# CMP213 Project TransmiT TNUoS Developments

## Consultation Responses

Published on: 28<sup>th</sup> March 2013

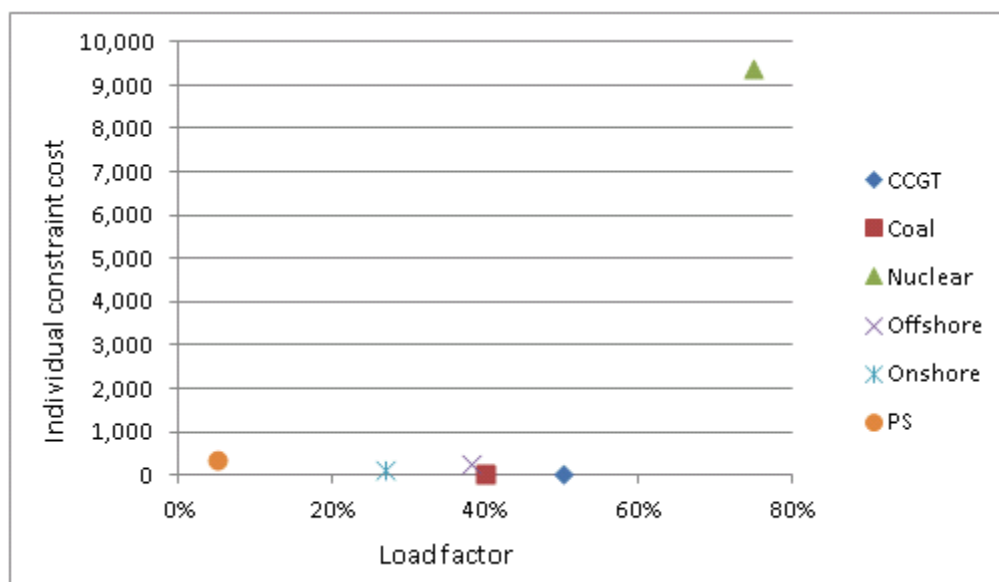
For example, we disagree with the proposition as illustrated in Figures 17, 18, 19, 20, 21, that there is one linear relationship between the load factor and incremental constraint costs of low carbon plant and a different linear relationship for non low carbon plant. We do not think that this has been clearly demonstrated and seems at odds with examination of actual bids and associated constraint costs.

As a result we have serious reservations over some of the detail in the proposed 'diversity' approach set out in paragraphs 4.123-4.150 as it appears to distort the effect of the proposal by substantially altering the quantity of transmission capacity that is available to share between generators (especially in Scotland, and in particular the B6 Cheviot boundary).

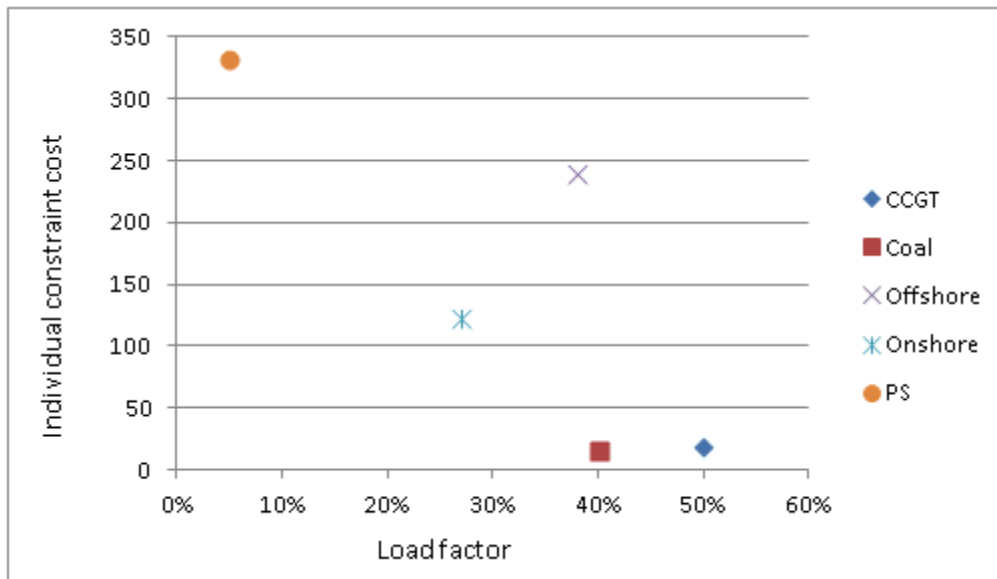
We have reviewed bid prices for a range of plant, covering over 17 GW of plant, for one month from 24/11/12 to 24/12/12. (This period has been used as it is the most recent month available excluding the Christmas holiday period). In the following graph we show the calculated marginal constraint cost associated with these bids. This shows that there is not a strong relationship between plant load factor and bid cost according to the definition carbon and low carbon. The relationship is not clear as the bid cost of nuclear is so much lower than that for the other technology types.

Using a truncated scale for the constraint cost (y-axis) helps outline the relationship for the non-nuclear plant. Nuclear plant is excluded as its constraint cost is outwith the y-axis range. It is clear that the relationship between load factor and constraint cost does not split along carbon and low carbon lines.
